ADDENDUM

PROJECT TITLE: PUBLIC SPACE AT MARKET SLIP & HARBOUR PASSAGE EXTENSION	ADD. NO: 3
TENDER NO: 2022-081201T	DATE: July 14 th , 2022
PAGE 1 of 11 (Including Confirmation Sheet)

**PUBLIC SPACE AT MARKET SLIP &
HARBOUR PASSAGE EXTENSION**

ASK11

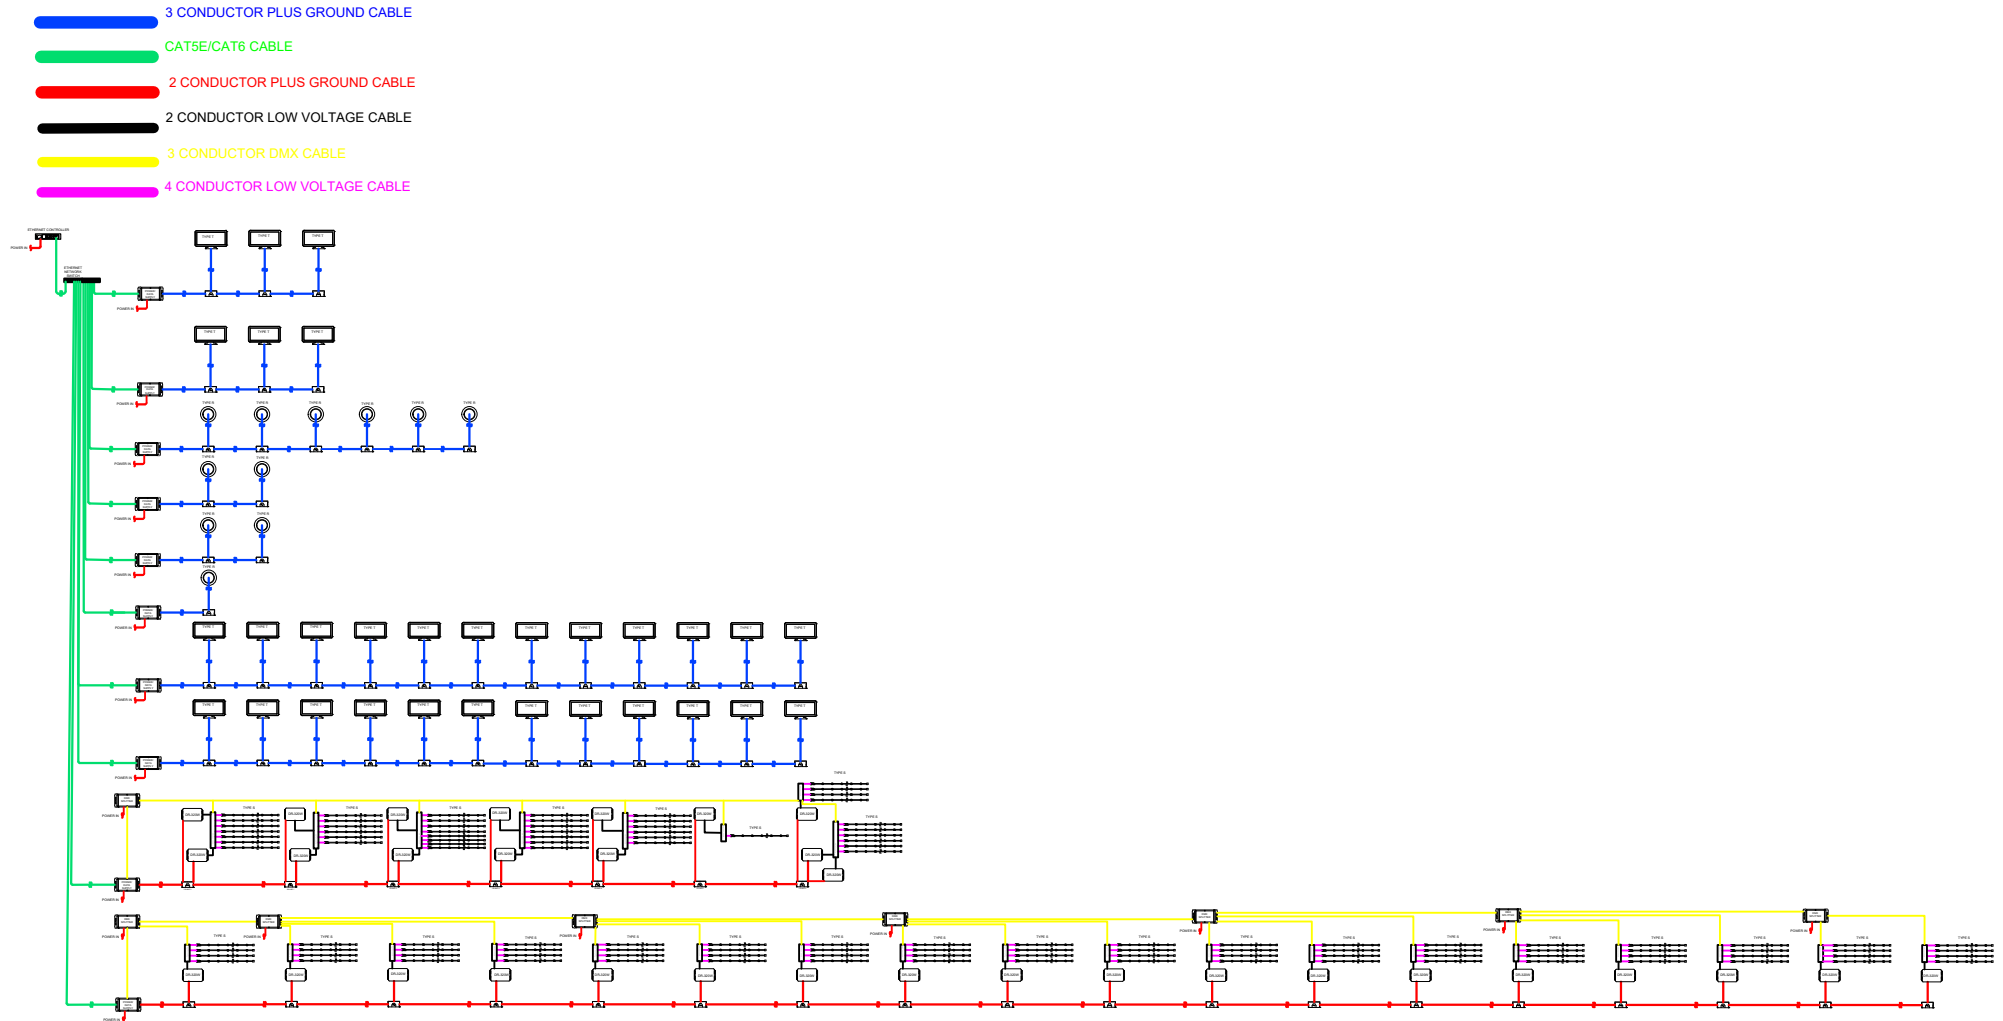
- c. Where are the RTDs in the heat trace schematic mounted - on the exterior of the stage building?

- d. Is the heat trace cable run all the way from the stage basement, out around the bollards, and returning to the basement before the end seal kit is installed? Could the PJB not be mounted out in the buried pull box near the bollards? Could the end seal not be installed in the same pull box, or at the last bollard location?

Attached drawings E1.0 and ASK 11 are to be included in the drawing package.

Answer: RTD to be mounted below seating area near pull box.

Answer: Yes, PJB is to be mounted in the seating area near the pull box. End seal termination location to coordinated with the vendor, if possible bury the connection with the cable.

E1.0

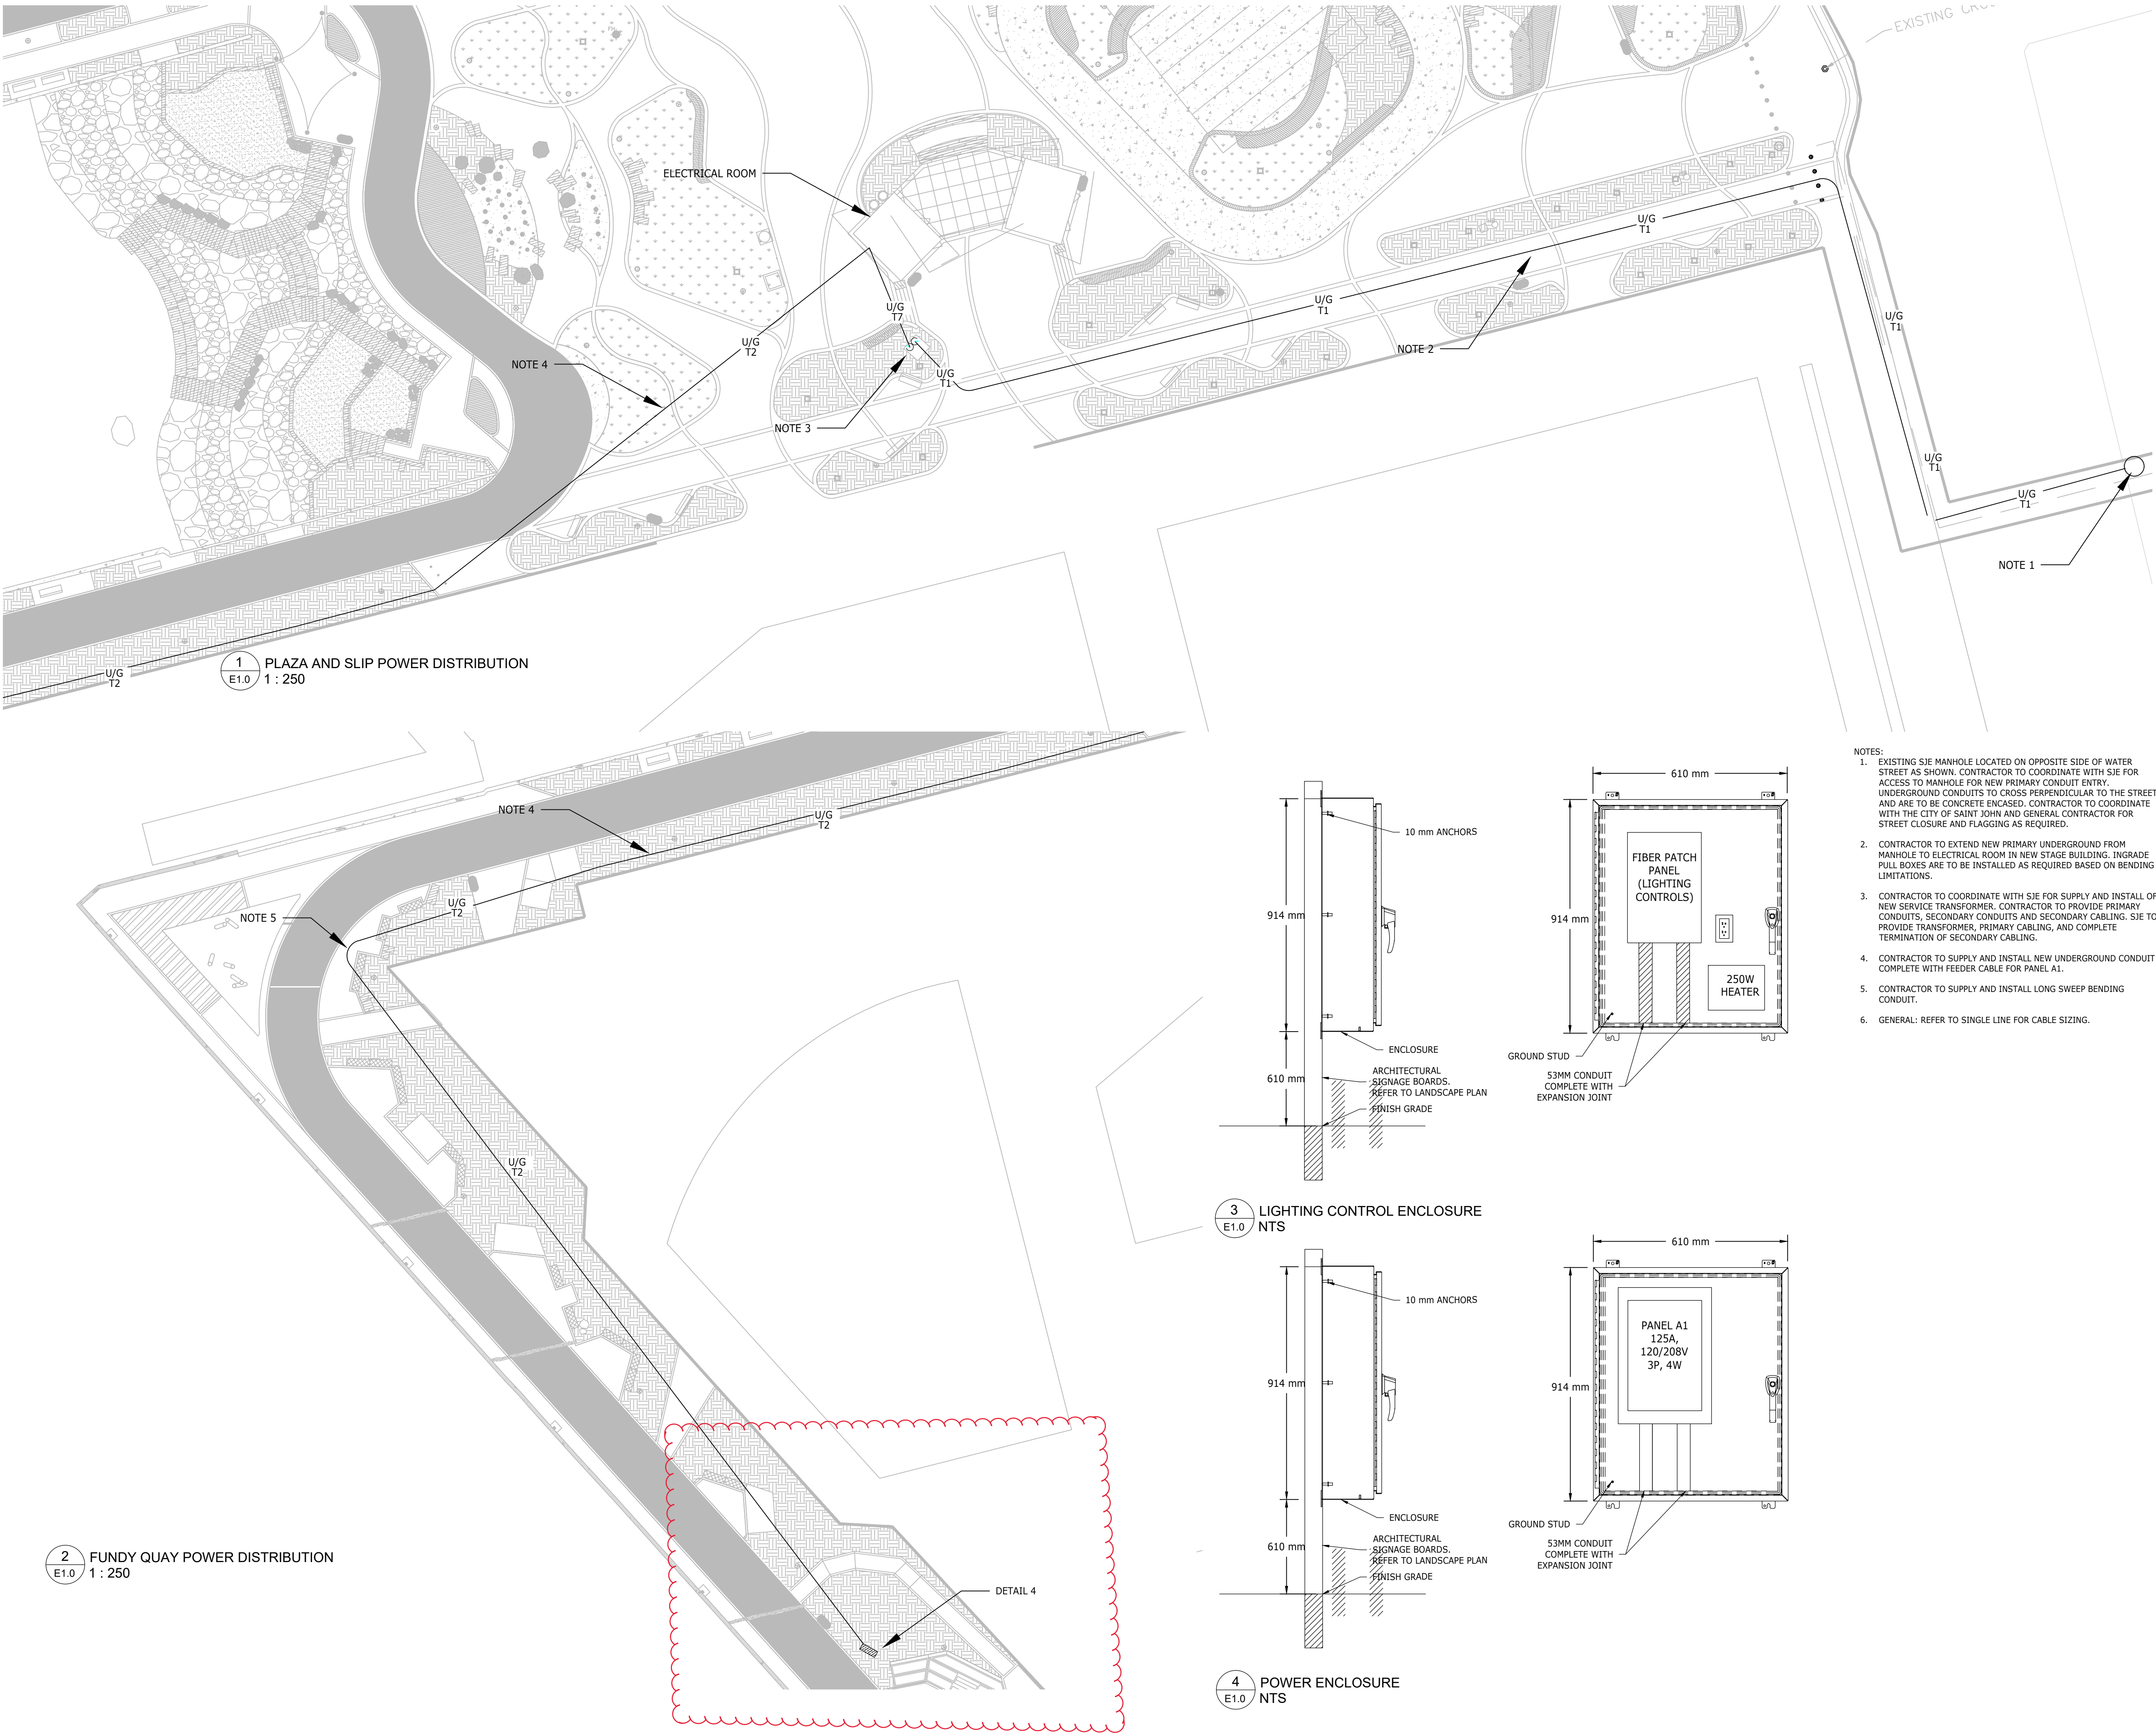
1. Drawing E1.0

a. Where is the lighting control enclosure located?

b. Is the fiber patch panel in the lighting control enclosure supplied by the Owner?

Answer: Attached is updated drawing E1.0

Answer: The fiber Patch panel is by the contractor. Corning WCP-04P or equal.
